PROJECT: GOODWILL @ DURANGO & DEER SPRINGS

CITY OF LAS VEGAS		DATE:
INTER-OFFICE MEMORANDUM		November 4, 2014
TO: Land Development Services Department of Building & Safety		FROM: Albert Sung, P.E. Flood Control Project Engineer Department of Public Works
SUBJECT:	Drainage Study for:	COPIES TO:
	Goodwill at Durango & Deer Springs	Rietz Consulting, Inc
Cross Streets:	NWC of Durango Road & Echelon Point Dr.	BCP-Deer Springs, LLC
File Number:	F:\Depot\DSMemos\DS4704A.doc	Bart Anderson, P.E., DevCo
Parcel Number:	125-20-301-028	
Zoning Action:	MOD-55735 & SDR-55737	
FEMA Flood Zone	YES NO X	
Proposed Storm Drain	YES X NO

TECHNICAL DRAINAGE STUDY

GOODWILL

GRADING PLANS

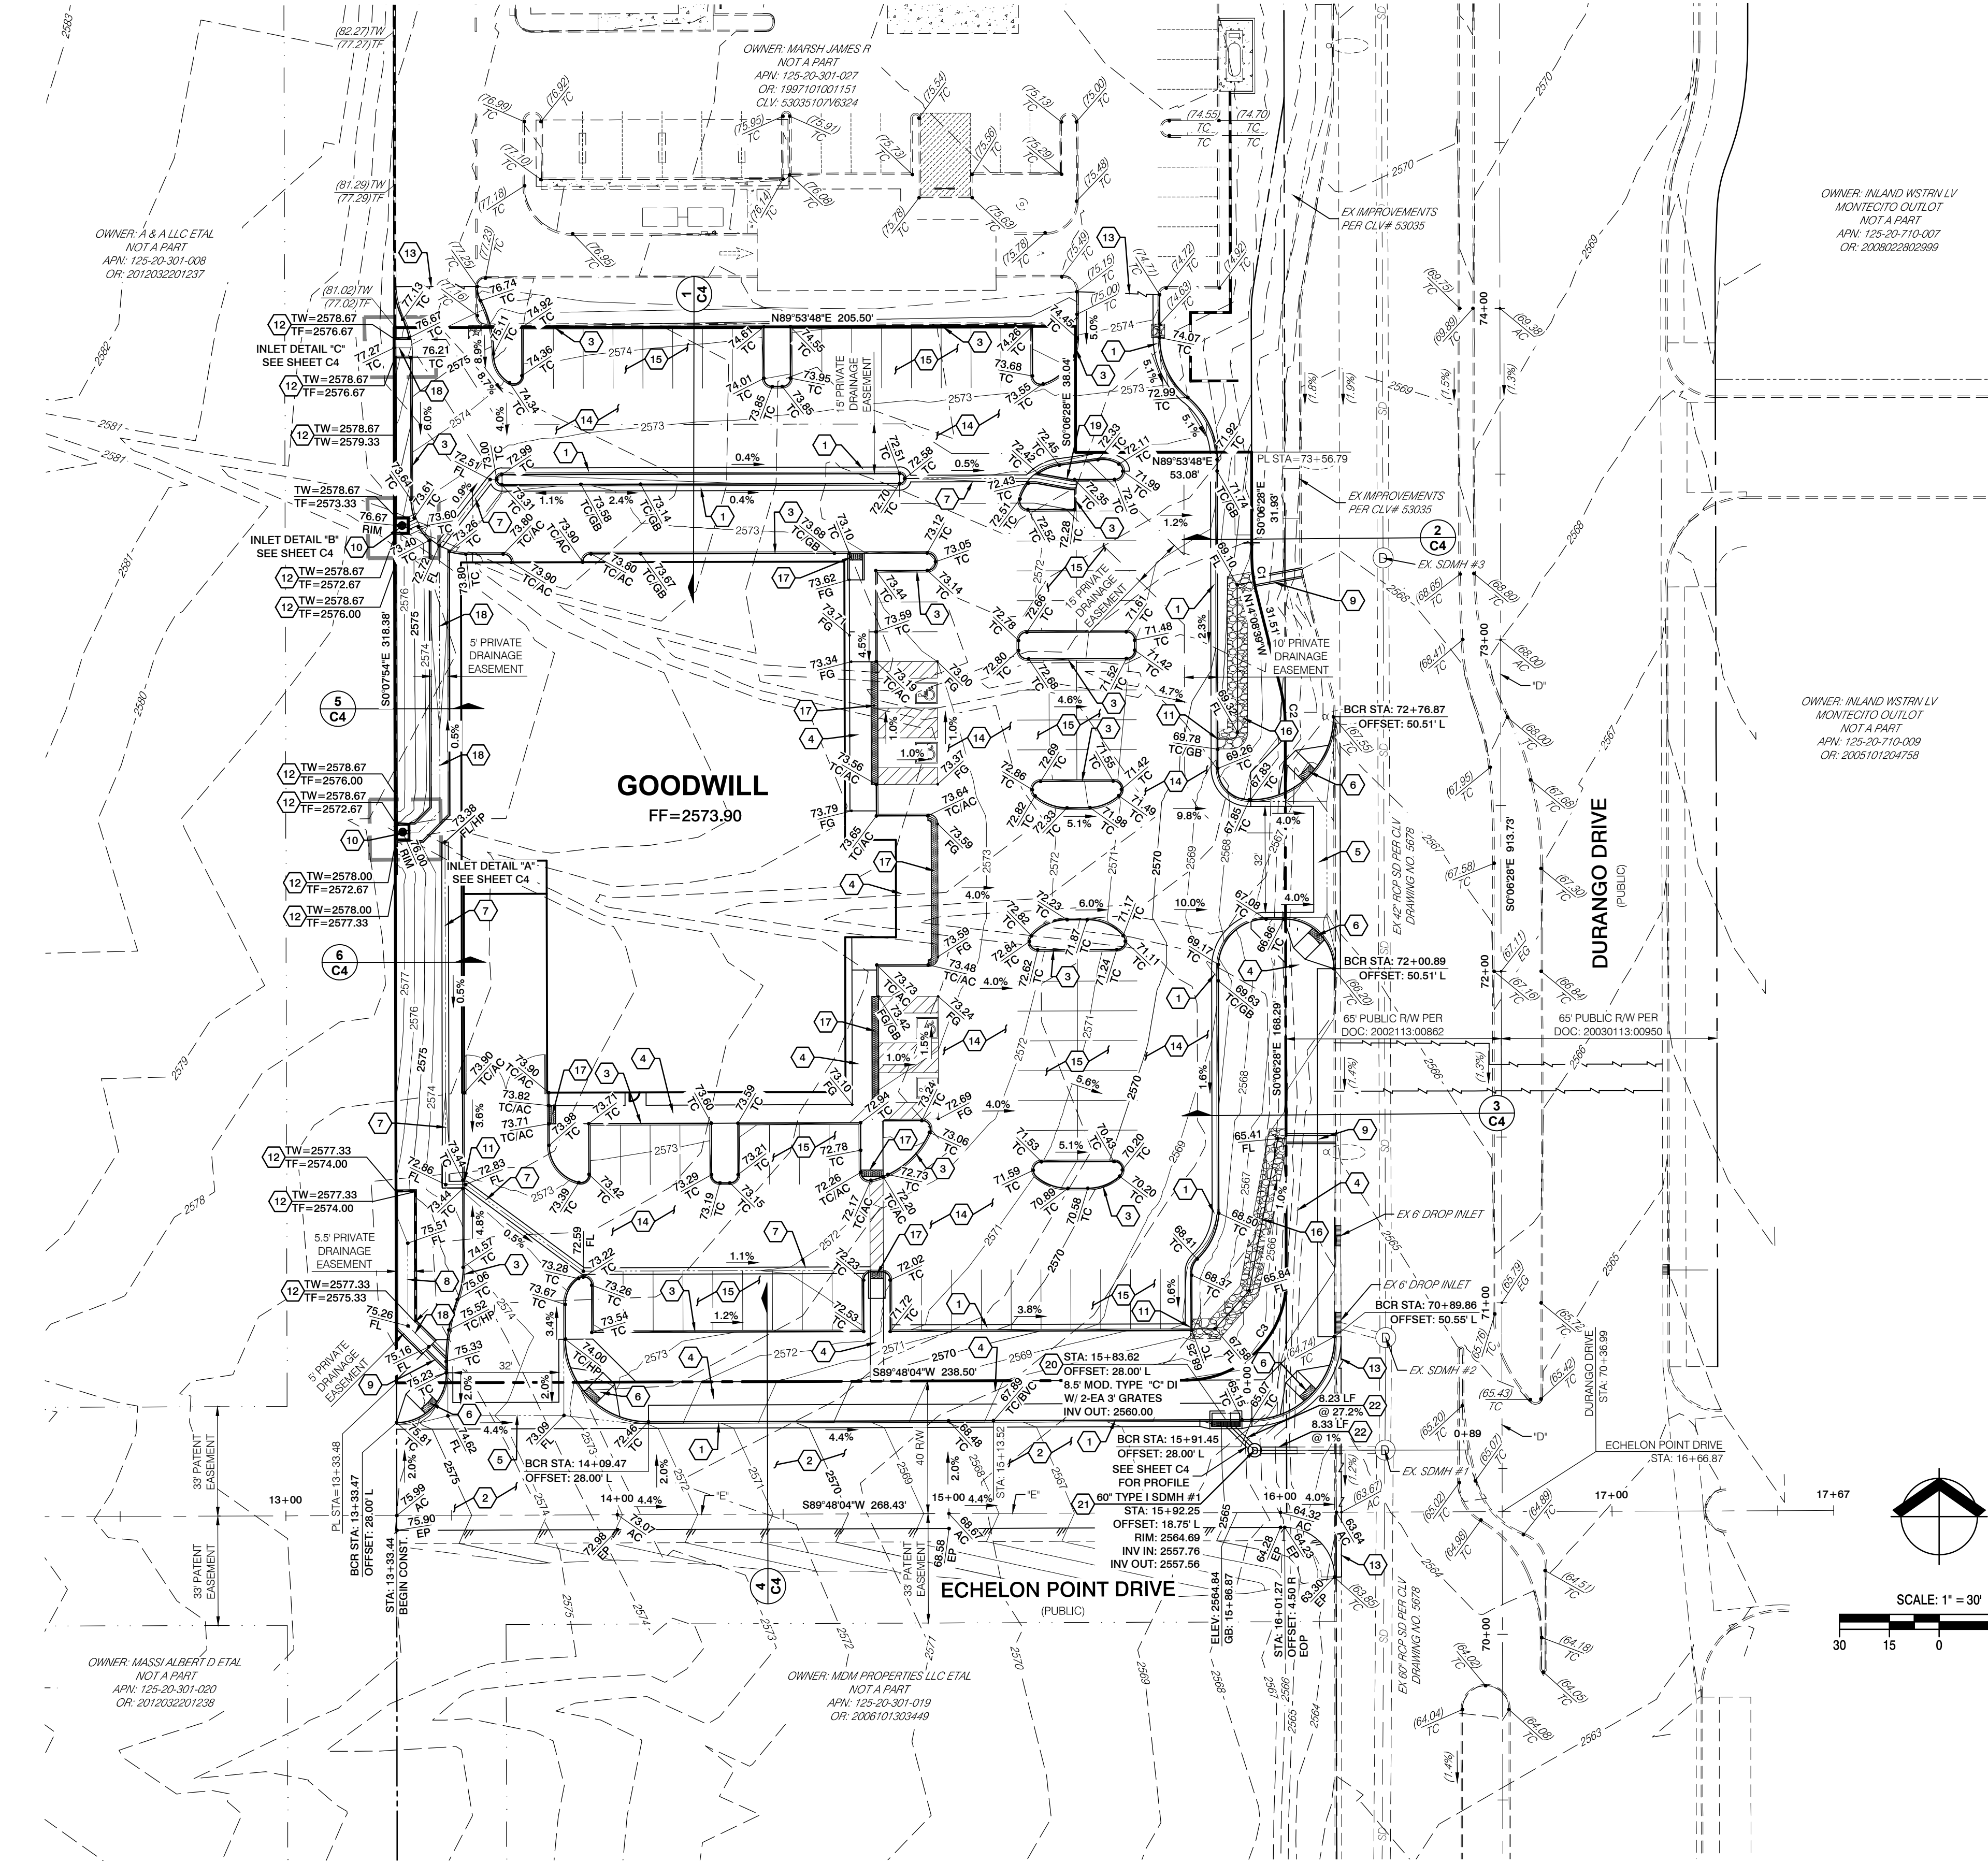
2. Sites with a grade difference of 2 feet above or below existing are required to have approval from the *City Planning and Development Department*. The engineer must submit copies of the grading plans and detail sheet with a letter justifying the grade difference to the *City Planning Department* (229-6301). The engineer must provide Planning approval with the next submittal.

5. All drainage easements must be public drainage easements to be privately maintained by the property owner to be labeled on the grading plans and to be dedicated as such in the final map or by separate document. The minimum width for a public drainage easement is 10' if the 100-year flow is less than 20 CFS. Revise the grading plan and all pertinent details accordingly.

7. Revise all drop inlets to Type "CM" or Neenah Pre-cast inlets. Contact Raul Cruz at 229-3224 for an AutoCAD detail to be included within the improvement plans if Type "CM" drop inlets are used. Note that the lengths of "CM" inlets are in the multiple of 2.5'. Revise all pertinent construction notes and callouts accordingly.

ECHELON POINT DRIVE PLAN AND PROFILE

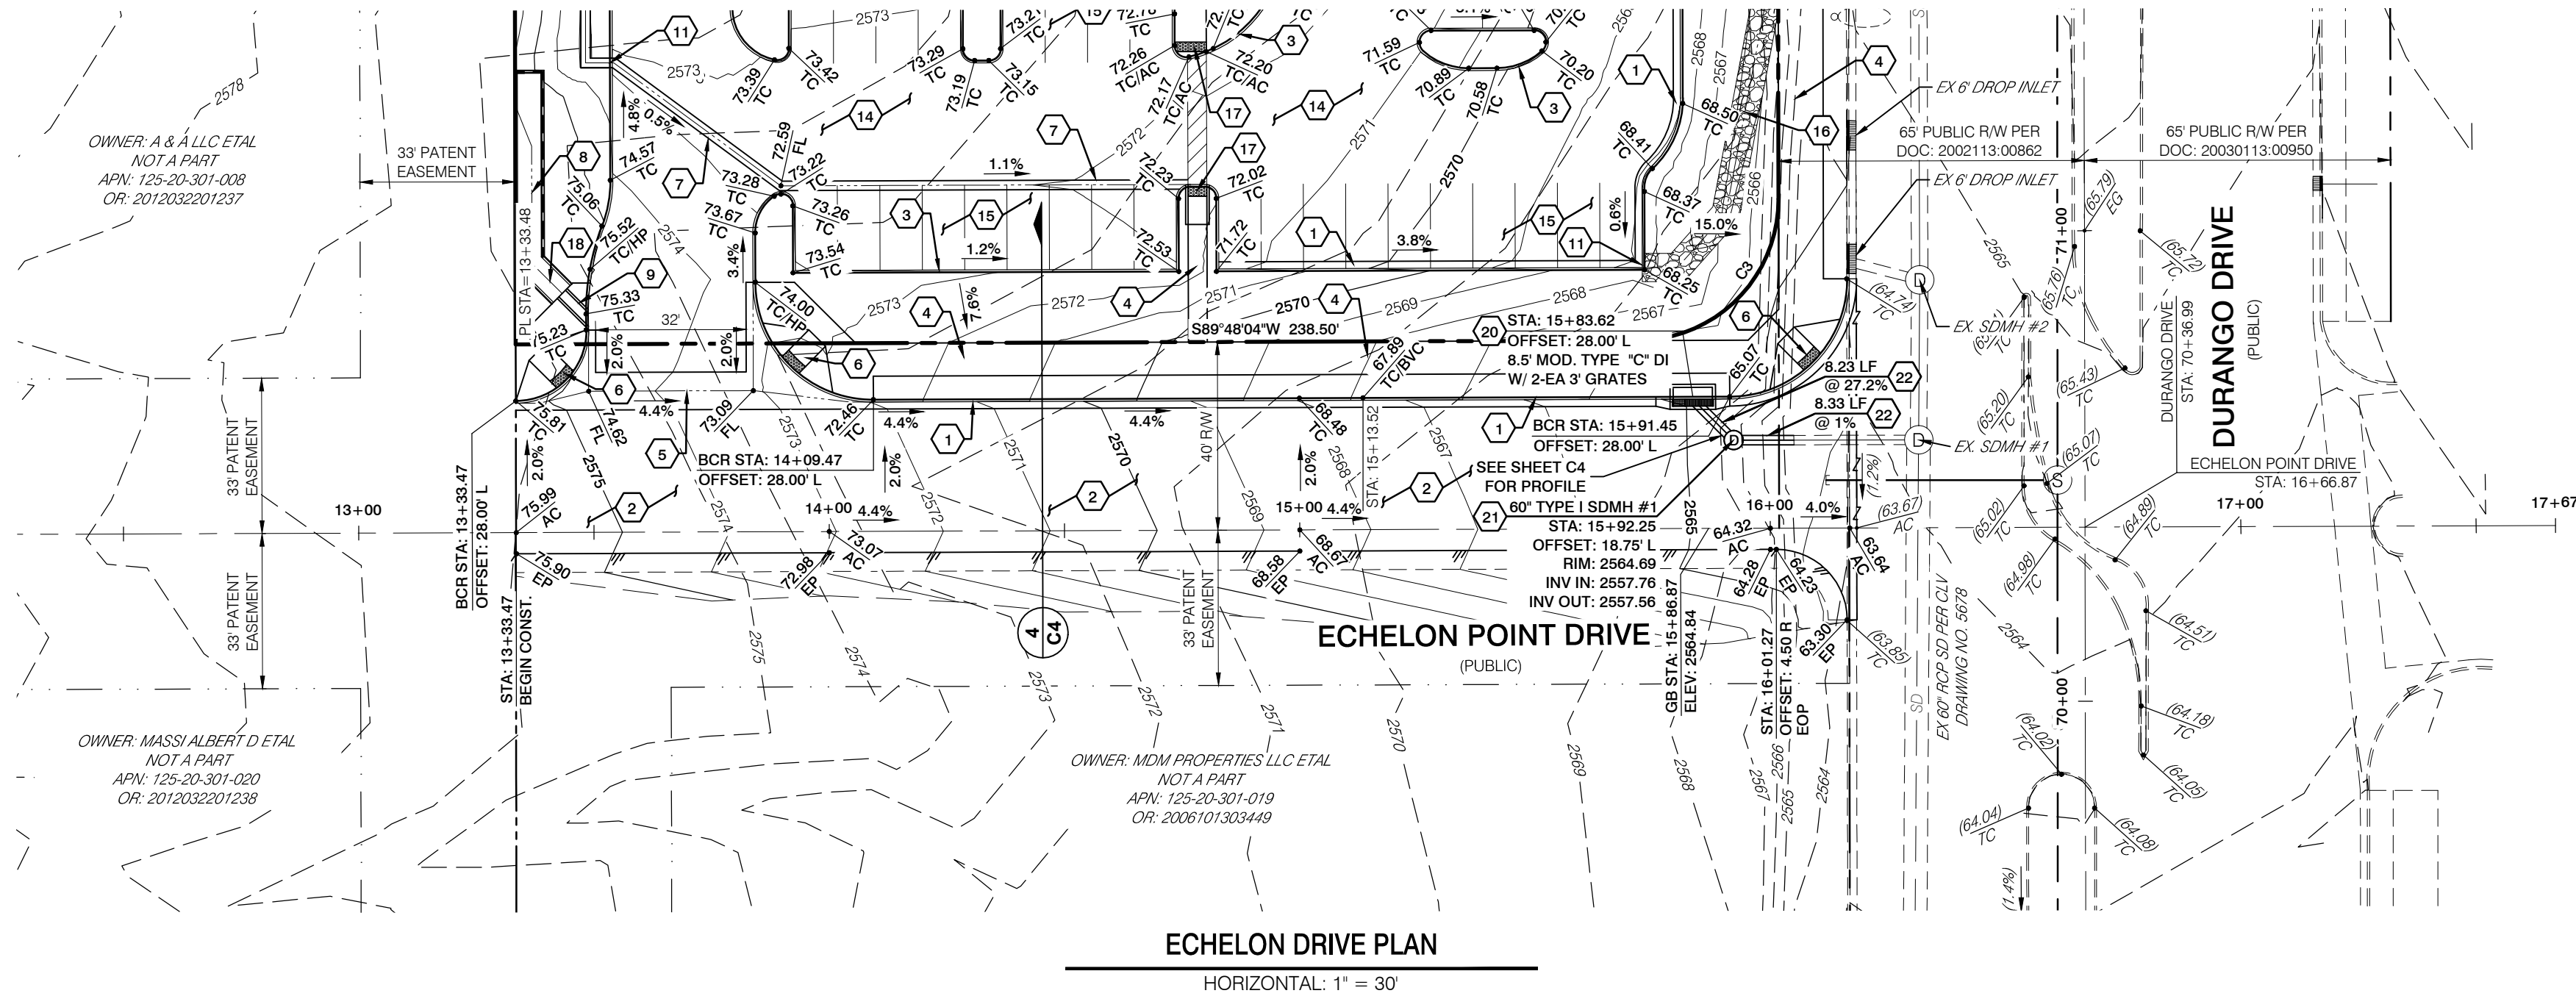
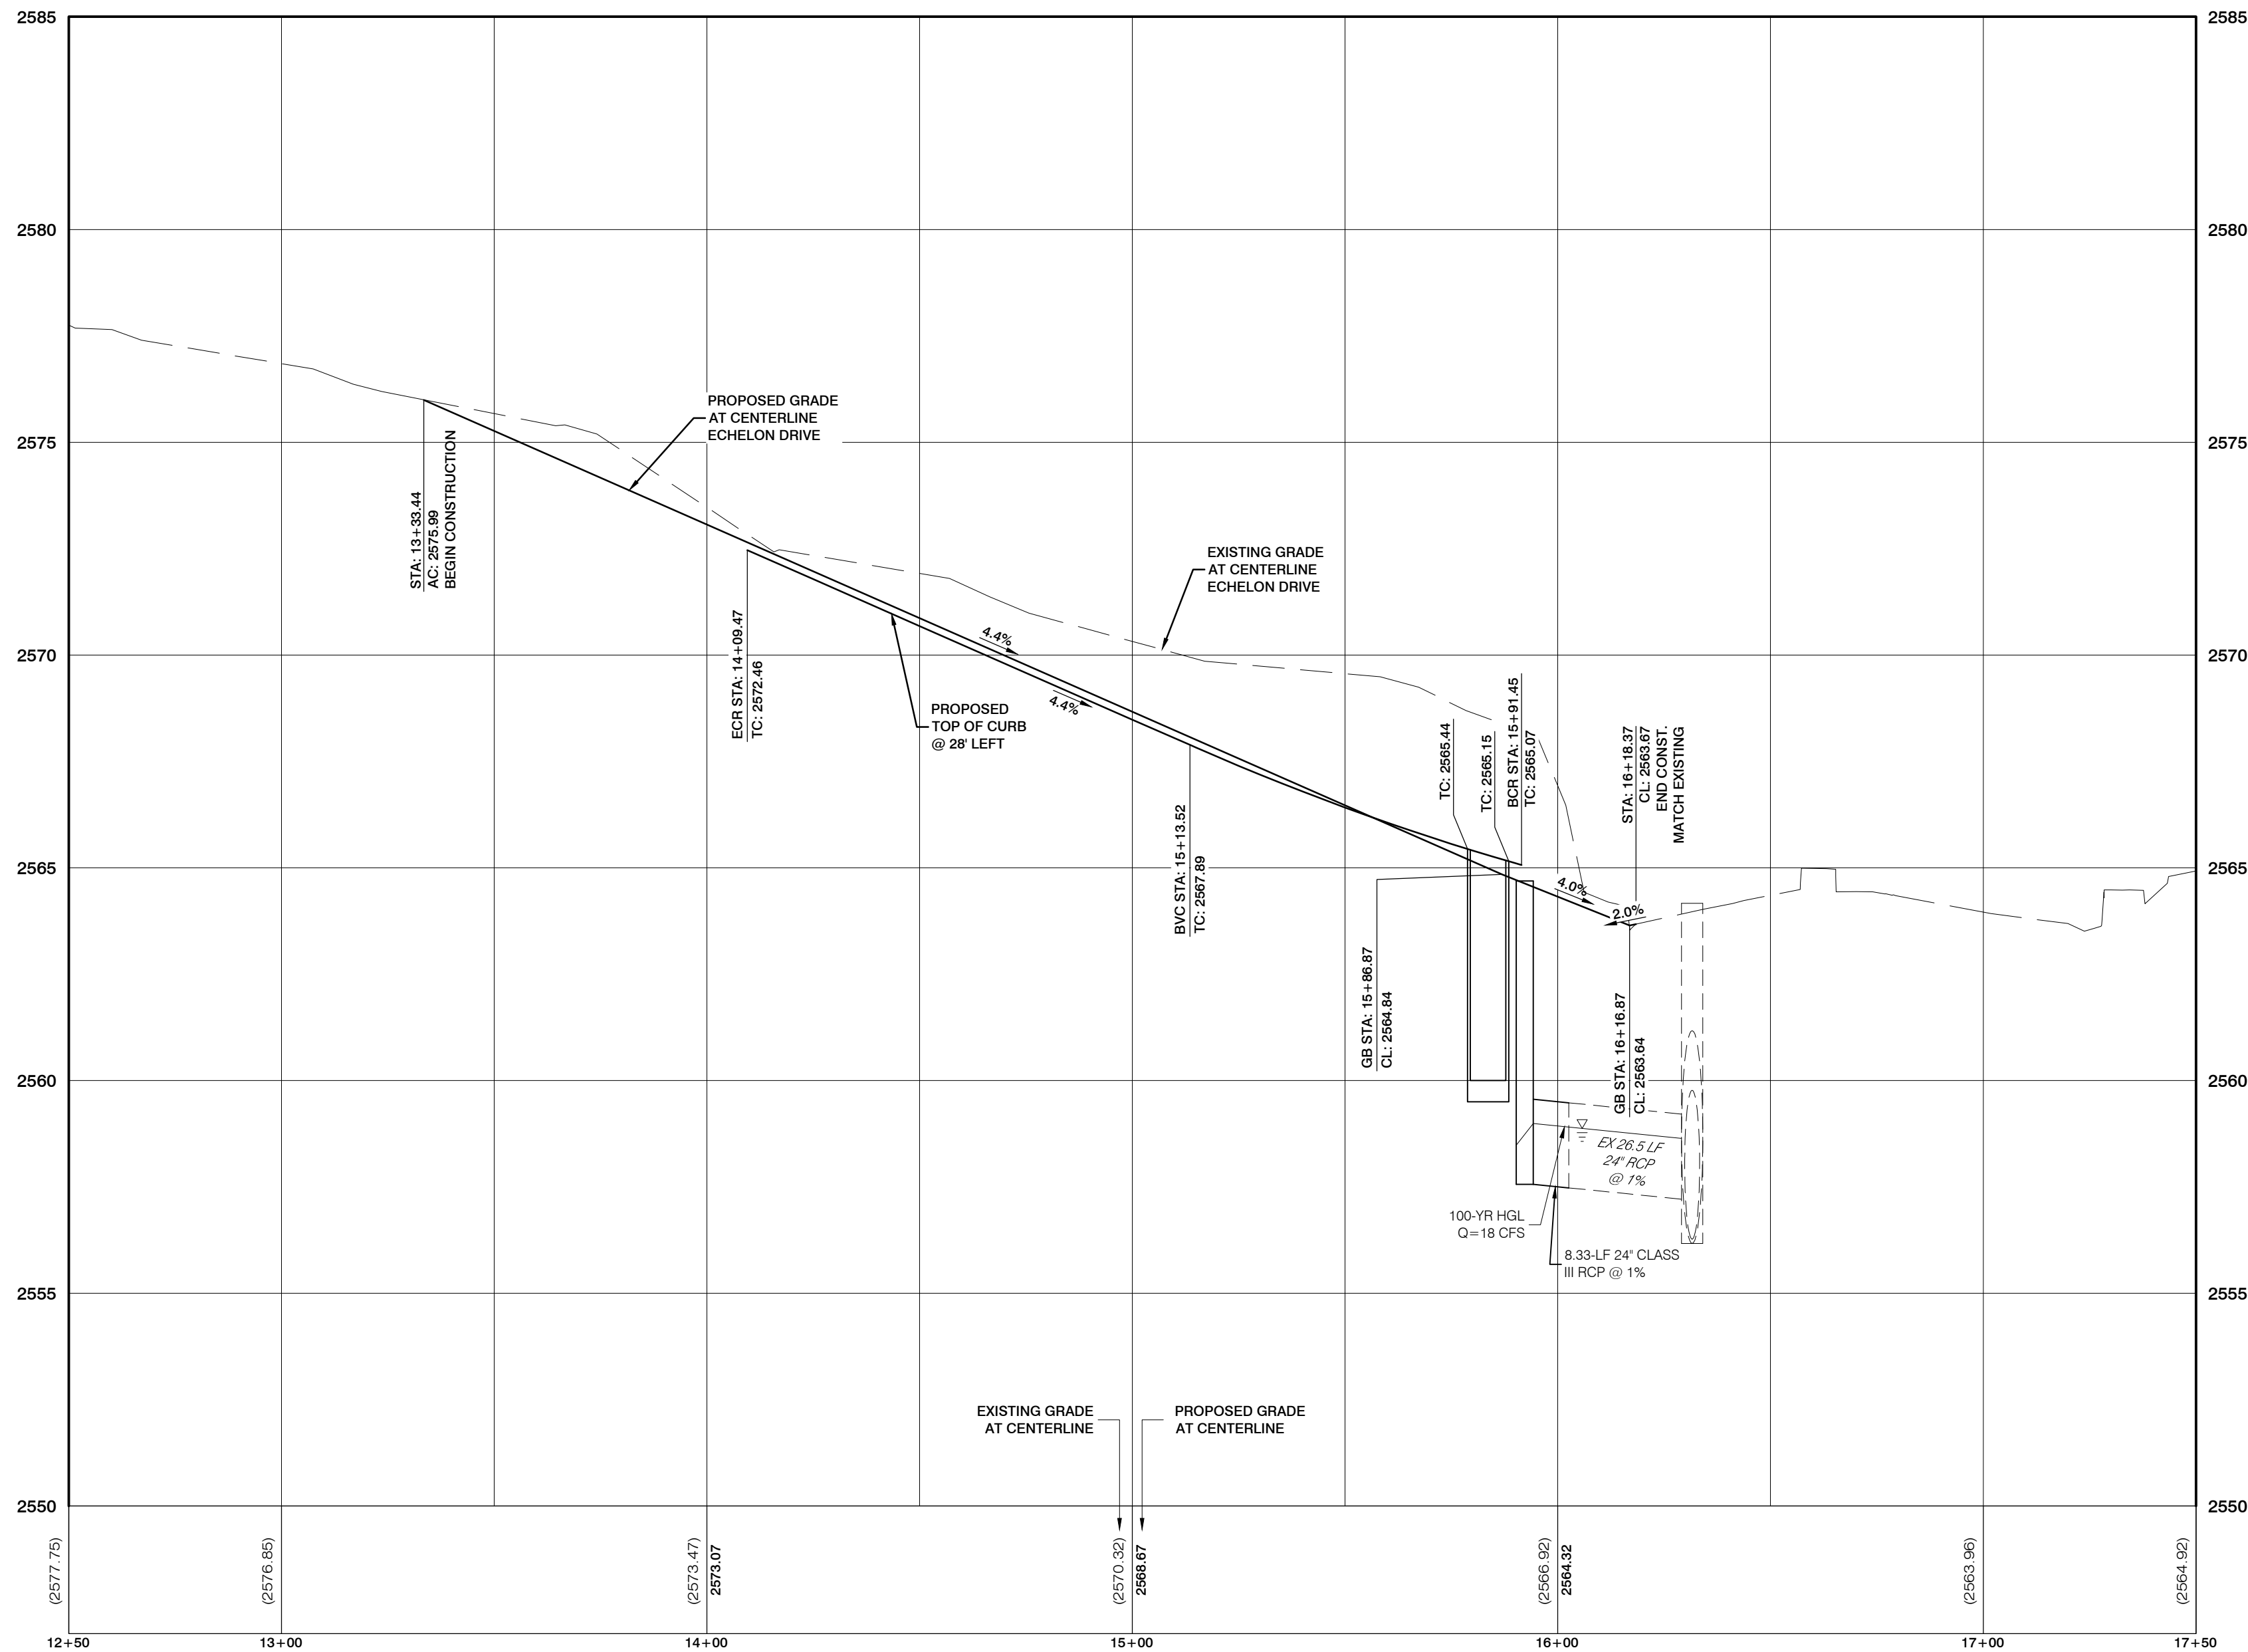
3. The proposed finished floor elevation of the new building does not meet regional criteria as to *Echelon Point Drive*. The corresponding flow line elevation in *Echelon Point Drive* per the high side of the building is 74.62FL, the proposed building is set at F.F. =73.90 which is lower. Without providing twice-the-depth (100-year storm event), an alternative remedy is to provide a hump at the driveway with a minimum of six inches freeboard. However, the proposed TC/HPs in the driveway entrance in *Echelon Point Drive* with $d_{100}=0.60'$ also do not meet the criteria. Review and revise accordingly.

8. It is proposed to connect a new 24"-RCP to an existing 24"-RCP in *Echelon Point Drive*. Provide a connection detail in the next submittal.
9. The drawing number labeled on the grading plan for an existing storm drain system in *Durango Drive* is not correct. Review and revise accordingly in the next submittal.
